SERVICE BULLETIN

REPLACEMENT OF WASHER PART NO. 944072 (FLY WHEEL HUB) FOR ROTAX® ENGINE TYPE 912 AND 914 (SERIES)

SB-912-058UL

SB-914-041UL

Fig. 1

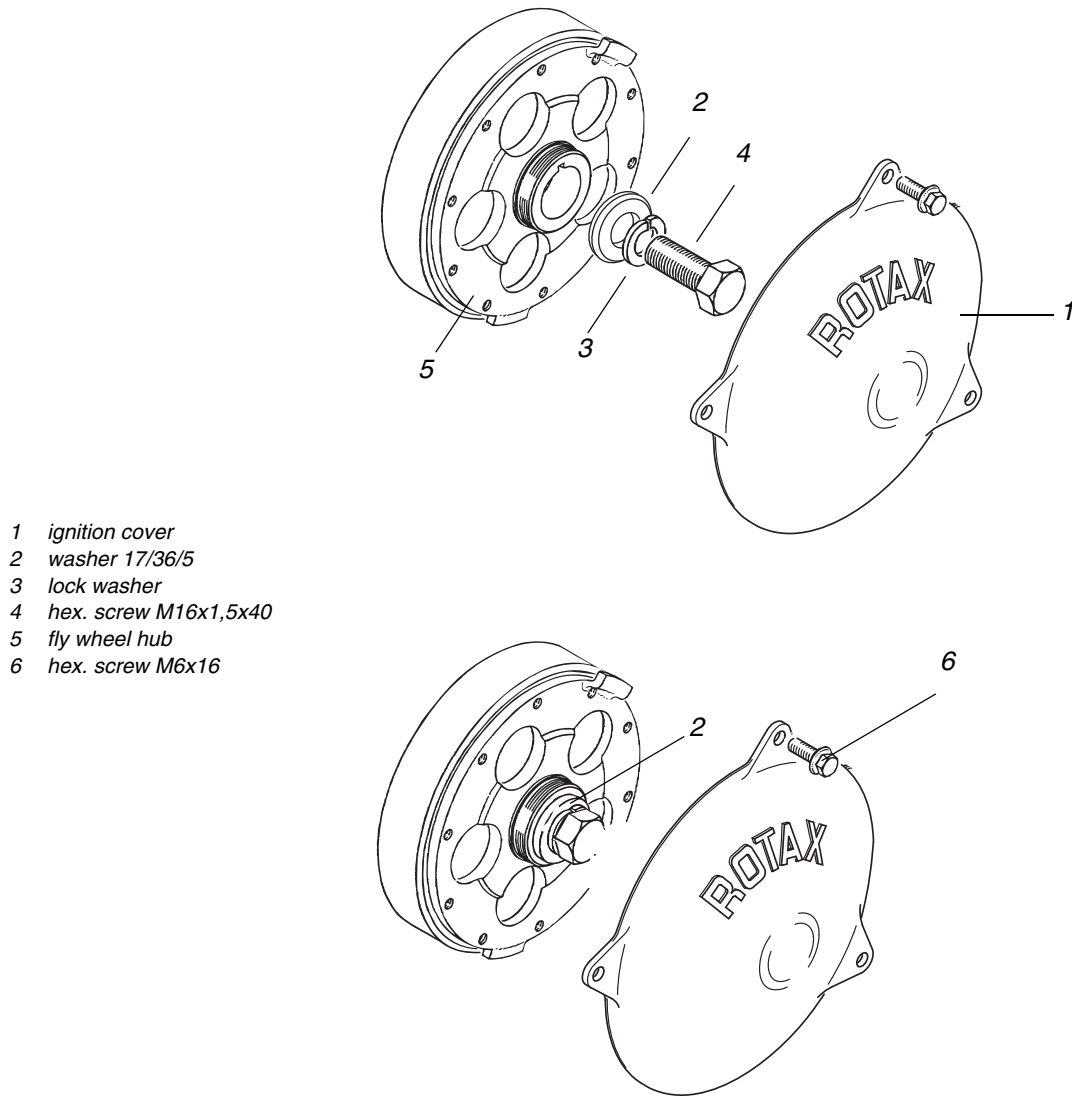
A deviation in hardening process could cause an exceeding of hardness of certain washer. This deviation could lead to cracks in the washer and could cause loosening of fly wheel, ignition failure or engine damage.

Replacement of washer part no. 944072 (fly wheel hub) for ROTAX® engine type 912 and 914 (Series).

3.1) Replacement of washer part no. 944072

See fig. 1.

1. Remove ignition cover (1).
2. Lock the crankshaft in accordance with the relevant Maintenance Manual (Line).
3. Remove hex. screw (4) in accordance with the relevant Maintenance Manual (Heavy).

■ CAUTION: If the fly wheel hub has loosened during the disassembly and/or in case of doubt, then remove, clean and install the fly wheel hub in accordance with the relevant Maintenance Manual. In this case the tightening torque is 45 Nm (33.2 ft.lb) + 180° angle to rotation.

4. Install hex. screw (4). **Tightening torque 120 Nm (89 ft.lb).**

■ CAUTION: During installation the new washer (2) part no. 944072 must be used.

5. Remove locking pin of crankshaft in accordance with the relevant Maintenance Manual.
6. Check trigger coil gap, if necessary adjust it in accordance with the relevant Maintenance Manual.
7. Install ignition cover (1). The hex. screws (6) are locked with Loctite 221. Tightening torque 5 Nm (44 in. lb.).
